UNITED STATES PATENT AND TRADEMARK OFFICE

APPLICATION NO.	FILING DATE	FIRST NAMED INVENTOR	ATTORNEY DOCKET NO.	CONFIRMATION NO.
10/551,624	06/26/2006	Stephane Moreau	17258/002001	5504

Office Action Summary	Application No.	Applicant(s)	
	10/551,624	MOREAU ET AL.	
	Examiner	Art Unit	
	ALEXANDER COMLEY	3746

DETAILED ACTION

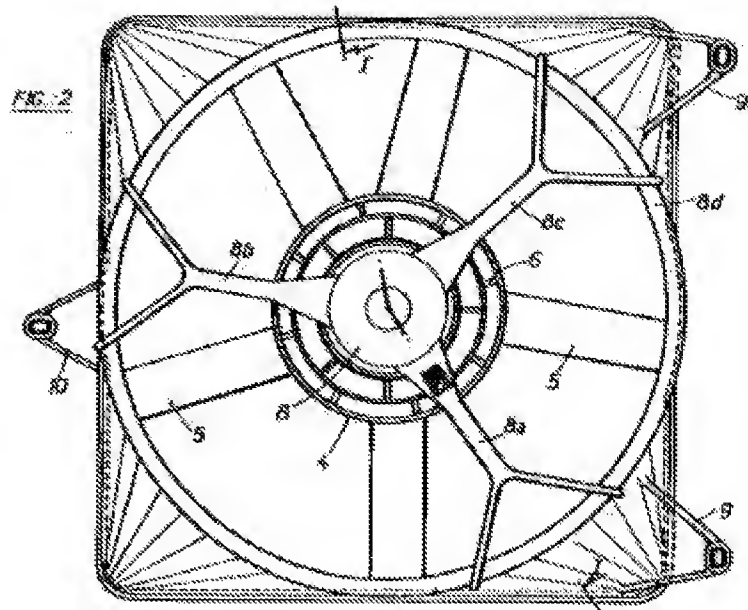
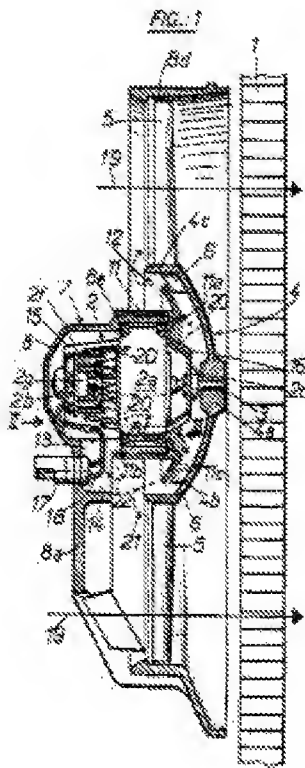
In regards to Independent Claim 1, and with particular reference to Figures 1-2 shown immediately above, Neveux discloses a motor-fan unit (i.e. ventilation device) for the cooling of the circulation water of an automotive internal combustion engine (see Abstract). As shown above, a fan composed of blades 5 is rotationally driven by an open electric motor 2 which is firmly attached to a central support housing (7, 8, 11). Central housing (i.e. central part) is supported by three surrounding support arms (8a-8c), a support collar 8d, and fixing lugs (9, 10). Such a support allows the motor-fan unit to be supported behind a radiator of an automotive engine such that the air circulated therethrough can cool the water flowing within the radiator in a well-known manner (see col. 2, lines 26-30). Central housing 7 is comprised of front (8) and rear (11) housing portions that tightly engage with one another in order to fixedly secure the

motor 2 therein (see col. 2, lines 40-53) Motor 2 is of the open type such that its electrical circuits are freely exposed to atmosphere (see col. 2, lines 64-65). A motor shaft 3 extends out of motor 2 and is fixedly connected to a rotor 4, which is comprised of a central hub 4a, circular wall 4b, and peripheral part 4c. As seen best in figure 1, the rotor 4 forms a bowl shape, inside which internal cooling ribs/blades 6 are formed for ventilating the interior of the electric motor 2 (see col. 2, lines 30-39). As seen in best in Figure 1, an annular opening (i.e. through hole) is disposed within housing 7 and is formed complementary to the outer wall of motor 2. The opening extends directly through the center thereof such that the motor is received and held therein (see Fig. 1). Neveux further discloses that the interior shoulder 8e and resilient abutments 11a of the opening directly engage (i.e. are in contiguous sealing contact) with the outer edge of the motor ring 2a (see col. 2, lines 46-49). As such, it appears that Neveux discloses all of Applicant's claimed elements.

4. In regards to dependent **Claims 9-10**, see Col. 2, lines 45-53 of Neveux, as well as the analysis for Independent Claim 1 above. Regarding dependent **Claims 11 & 14**, front housing 8 forms a curved, active surface positioned opposite the bowl-shaped rotor 4 (see Figure 1) such that cooling air entering the motor in a smoothly flowing manner. In regards to dependent **Claims 12-13 & 15**, the upper left-hand portion of front housing 8 forms a quarter of a circle with the flat, linear left end face forming a substantially transverse portion and the flat, top face forming a substantially axially extending portion (parallel to motor). It is apparent that the housing 7 forms an annular-

shaped (i.e. hole shaped) opening that extends opposite that of the rotor bowl 4.

Regarding dependent **Claim 16**, Figure 2 clearly shows a collar 8d (i.e. peripheral part) forming a supporting frame that is connected to the central housing 7 via supporting arms (8a-8c). In regards to dependent **Claims 17-18**, Neveux clearly states that the motor-fan unit is for use as an engine cooling and ventilation device of a vehicle.

6. In regards to Applicant's argument that the housing 7 of Neveux is not in contiguous sealing contact with the outer surface of the motor, the Examiner must respectfully disagree. As stated above, Neveux's central opening extends directly through the center thereof such that the motor is received and held therein (see Fig. 1). Neveux specifically discloses that the interior shoulder 8e and resilient abutments 11a of the opening directly engage (i.e. are in contiguous sealing contact) with the outer edge of the motor ring 2a. In particular, Neveux states "Resilient abutments 11a are disposed inside back part 11 and cause the magnetic ring 2a of motor 2 to rest against an interior shoulder 8e of front part 8. Rib 8f is disposed externally of front part 8 and resiliently surmounts a step 11b of back part 11. Rib 8f becomes latched behind step 11b when back part 11 is engaged to front part 8. 2 is thus fixed in housing 7." (Col. 2, lines 46-53) Thus, Neveux specifically discloses a direct contact between the

surrounding housing 7 and the motor housing 2a whenever the front and rear housing portions are latched together. Therefore, the Examiner would respectfully assert that Neveux does, in fact, disclose and show Applicant's claimed continuous contiguous contact between the housing and motor.
